December 22, 2023

**Re: Comments submitted for consideration in the matter of a Section 106 Review for
Link5G Wireless Telecommunications Facility at
2800 Broadway and W 108th St, Manhattan, NY.
Site name: MN-07-120401_A (EBI reference # 6123006708)**

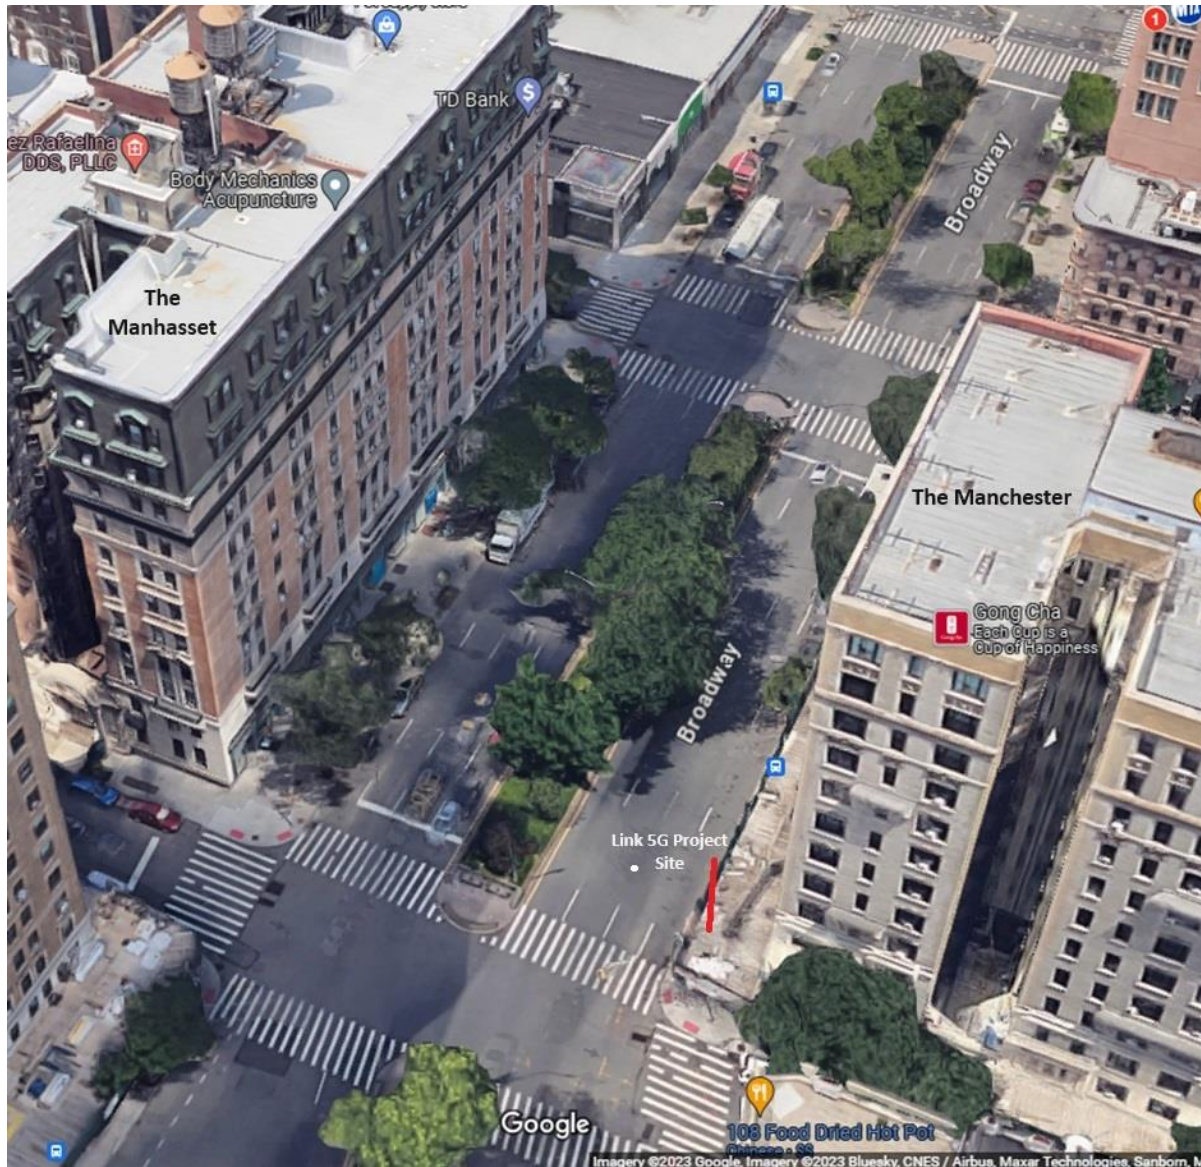
The supposed "visual buffers" described as "mature vegetation and utility infrastructure" do **not** entirely block the view of proposed tower Project Site from the Broadway facing windows of The Manhasset. While some views *from* the lower three stories of The Manhasset may be partially blocked during the six months of the year when leaves are on trees, this is an 11-story building. Meaning that the leaves will not block views from the other eight upper stories of the Manhasset.

The existing vegetation consists primarily of mature trees along the sidewalks and a combination of trees and low shrubs in the center median Broadway Mall that runs the length of the block. However, as can be clearly seen in Image 2 below there are no trees on the east side sidewalk nearest the project site. The approximately 4" diameter top of the tapered pole of the nearest streetlight/traffic signal is only about 1/8

of the 34" diameter of the proposed Link5G pole. Thus, the proposed wireless tower will be taller than all the trees and the streetlights – and substantially wider.⁴

What the description provided by applicant (as per footnote #2 on page 2 above) also fails to address is the impact that the Link5G tower will have upon the Broadway Malls center median to the overall setting. The Broadway Malls are, in fact, a series of block-long public park spaces that run along Broadway from

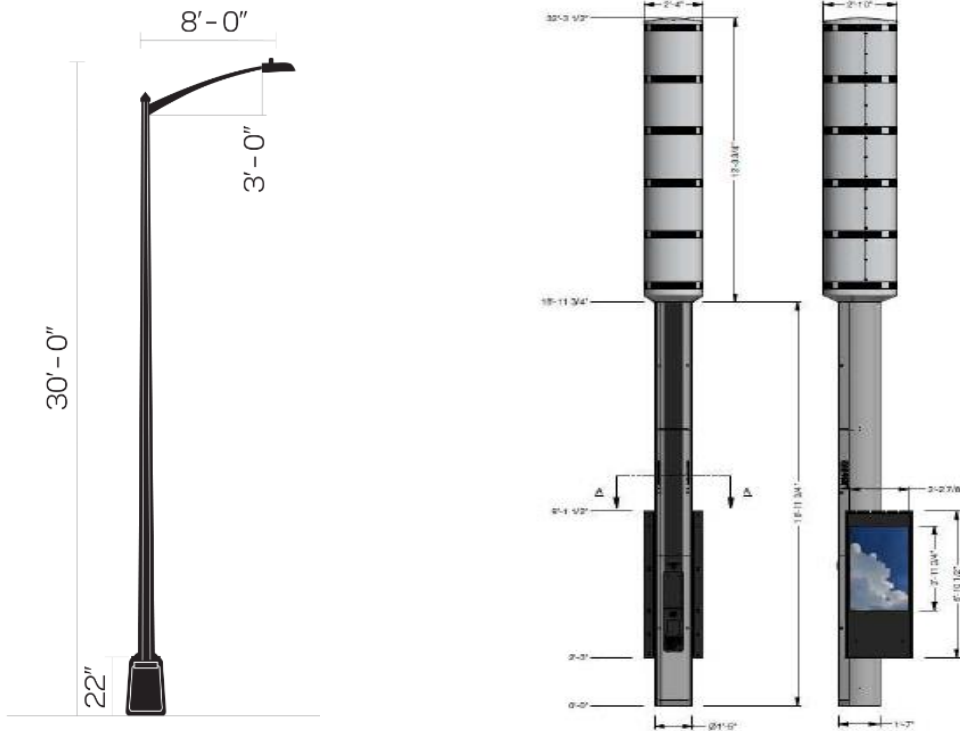
The Link5G structure will be both taller and significantly wider than the tapered streetlight visible in Image 3. Streetlights and traffic control signals at this intersection are Standard NYC DOT Octagonal Poles with extension arms. The Link5G will be more than 3 times taller than the existing LinkNYC kiosk. Note the Link5G shown below in Image 4 is NOT to horizontal scale. Rather, the widest point at the top of the cannister holding wireless antennas will be 34" while the tapered octagonal streetlight pole is only approximately 4" wide at top.

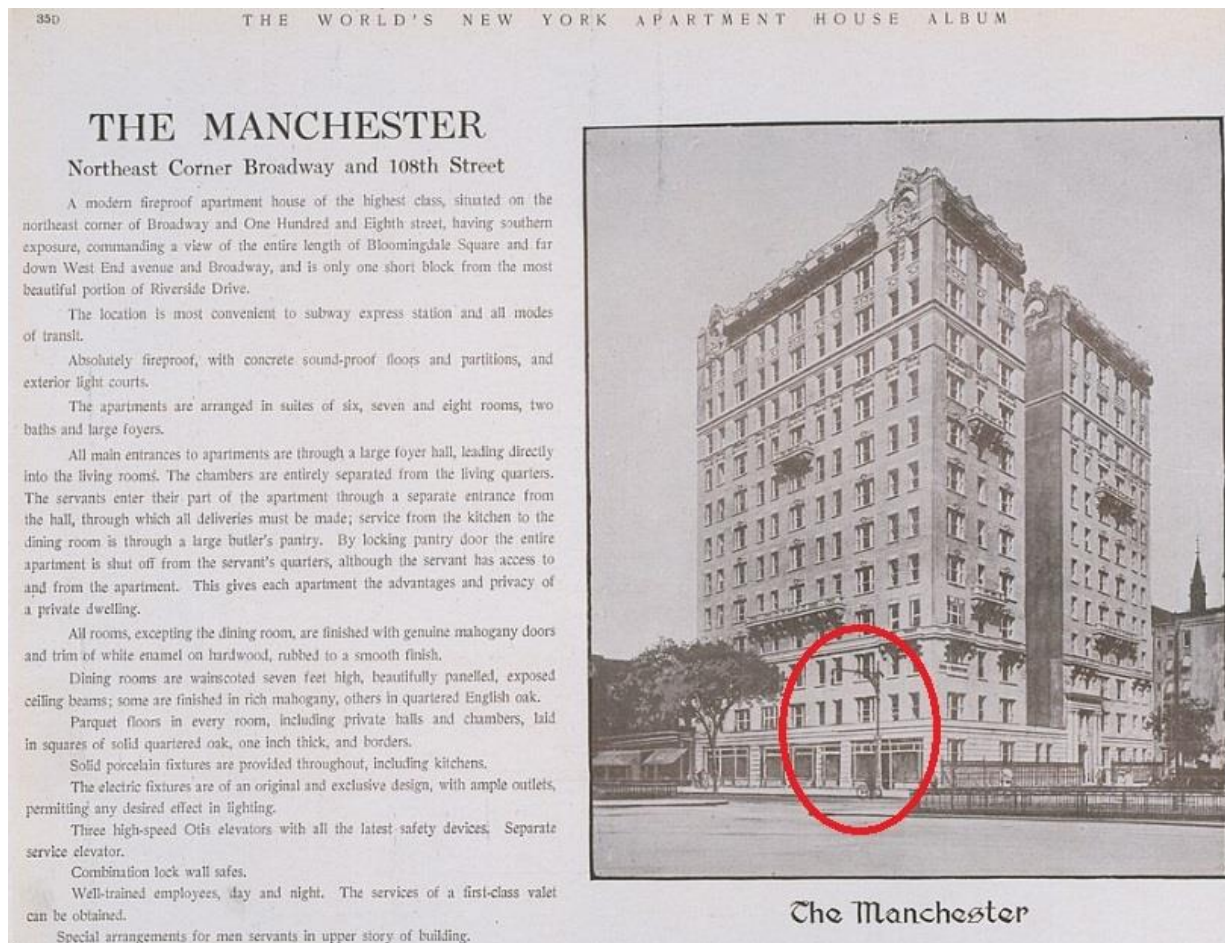
NYC DOT has worked hard with non-profit organizations and local residents to improve the streetscapes along Broadway most significantly through the restoration and maintenance of the Broadway Malls. There is hope that in coming years the next phase will be to remove all the unsightly and out of context modern street lighting and replace these with historically accurate Type-M poles that originally lined Broadway from about 1911 until at least the early 1960s, when they were subsequently replaced over time with so call existing “standard street light poles.”⁷ (Examples in original Type M poles are shown in Images 5 and 6 below.)

The precedent for the “reintroduction” of historic, early twentieth century cast iron streetlights was previously done as part of a massive reconstruction project in the mid-1990s along nearby Columbus Avenue from West 60th to West 110th Streets. It would be a calamity if historically accurate reproduction Type M poles - when they are reintroduced along Broadway - would have to compete with ultra-modernistic Link5G wireless towers. The applicant makes no effort to address the cumulative effects of these massive towers particularly in light of future potential to have them spaced mere blocks apart.
